15 November 2014

2014/3517/P, 6 Highgate Road, NW5 – Revised Plans
Proposed extension of two-storey property to four-storeys and alterations to shopfront

PROPOSED FRONT & REAR ELEVATIONS

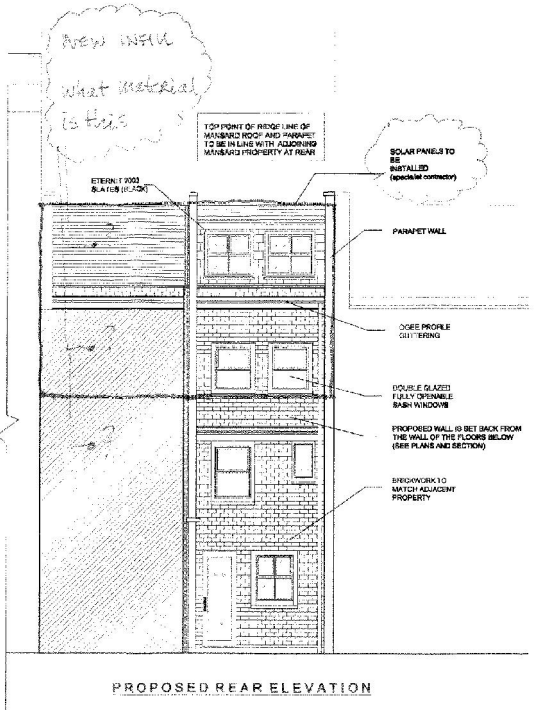
1. **Setting/listed buildings - Shopfront/sash windows - Elevational treatment - Solar panels**
(a) Is the entire building façade to be rebuilt? The existing first floor front window apertures are larger than proposed and have a traditional attractive brick arched top.
(b) Please ensure the sash windows are sliding and not 'top-hung-opening-out' sashes.
(c) Drwg. SSC 1000/PL02 indicates solar panels to the roof by specialist contractors. The mounting of these on the roof should be shown on the drawing. Such installation will substantially rise above the building's roof profile and be prominently visible in the context and setting of the listed buildings opposite. These should be sensitively designed in and shown before approval is granted. Alternatively solar receptors could be provided in the form of specialist roof tiling. These would be more appropriate to this location.

4. ***Plot Density/bulk of main extension/neighbours' amenity:***
It is appreciated that the rear proposed extension has been removed, however the proposed second storey + mansard would still be harmful to the amenity of residents in Fortess Road. The drawings deceive, as the proposed rear elevation SSC 1000/PL02 Rev A does not show the true extent of the proposed rising infill. I have marked in red on the attached drawing to show the full width & actual bulk of the infill in relation to *blocking daylight for neighbours. This is gross overdevelopment of a site that has no external space.*
The marked 'Open Area' on the drawings does not belong to the site.
A single storey extension configured as existing seems appropriate and can still provide a useful maisonette.

5. ***Rear Elevation/Fenestration/rear lower roof/neighbours' amenity:***
Fenestration at the rear elevation could be reduced in size as it conflicts with the internal arrangement on first floor kitchen, where there are already roof lights shown. If the mansard is to remain (which I think it should not) the shallow depth of the floor plan does not warrant the two windows facing the rear hemmed in space between buildings, and should be reduced to one window only to reduce overlooking.
The existing rear extension roof will still rise in height and drwg SSC 1000/PL03 Rev A implies railing as its parapet. If this were so, the use of this space as a terrace would be most inappropriate to the amenity of neighbours.
